PROPOSED TECHNICAL SPECIFICATIONS CHANGES

POWER AUTHORITY OF THE STATE OF NEW YORK JAMES A. FITZPATRICK NUCLEAR POWER PLANT DOCKET NO. 50-333

MARCH 9, 1981

Subject: Errata and Addenda Sheet No. 2 - LOCA Analysis Report

FIGURE 3.5-1 MAXIMUM AVERAGE PLANAR LINEAR HEAT GENERATION RATE (MAPLHGR) VERSUS FLANAR AVERAGE EXPOSURE REFERENCE NEDO-21662-2 TABLE SA FULL CORE DRILLED INITIAL CORE

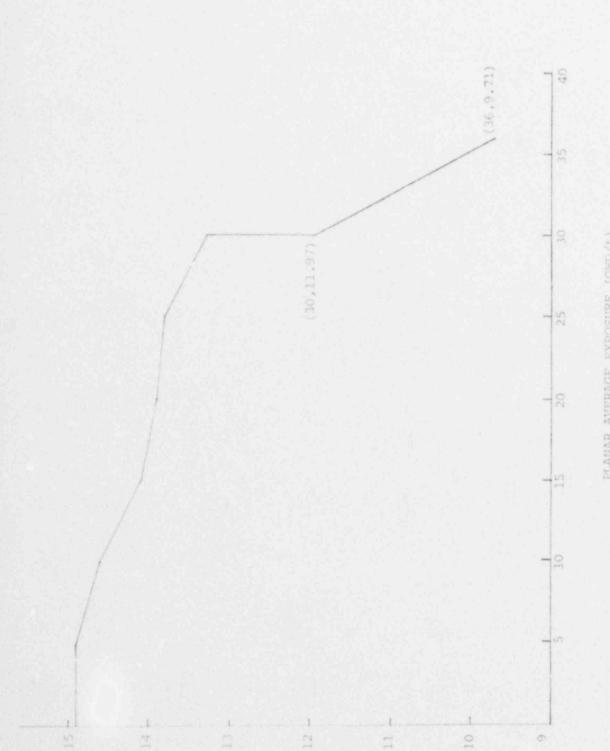
The proposed modification extends MPLHGR limits of 7x7 fuel to 36 GWD/t, thus extending the present limits of 30 GWD/t. The affected Technical Specification figures are Figures 3.5-1 and 3.5-2 and data for extending them were calculated and supplied by General Electric by letter dated October 21, 1980 (attached). These new data constitute a revision to the MAPLHGR Tables 5A and 5B in General Electric Report NEDO-21662-2. The General Electric data was modified for this application to incorporate penalties of 10% at 30 GWD/t and 20% at 36 GWD/t, as agreed in a telephone conversation with NRC on March 9, 1981.

During the present operating cycle (Cycle 4) the peak nodal exposure for 7x7 fuel is expected to surpass 30 GWD/t. This modification provides MAPLGHR limits consistent with presently accepted ECCS analysis, which allow operation beyond the present limit of 30 GWD/t.

The revised extension in MAPLHGR limits are more conservative than the attached amendment to General Electric report NEDO-21662-2, "Loss-of-Coolant Accident Analysis Report for James A. FitzPatrick Nuclear Power Plant" (lead plant) which was submitted to the Commission in a letter from George T. Berry to Robert W. Reid, Chief of Operating Reactors Branch, on July 29, 1977. This report forms the basis of the presently accepted ECCS analysis for the FitzPatrick plant; an SER issued by the Commission on September 16, 1977 references the Power Authority submittal. Thus the proposed modifications will not alter the conclusions reached in the FSAR and SER accident analysis.
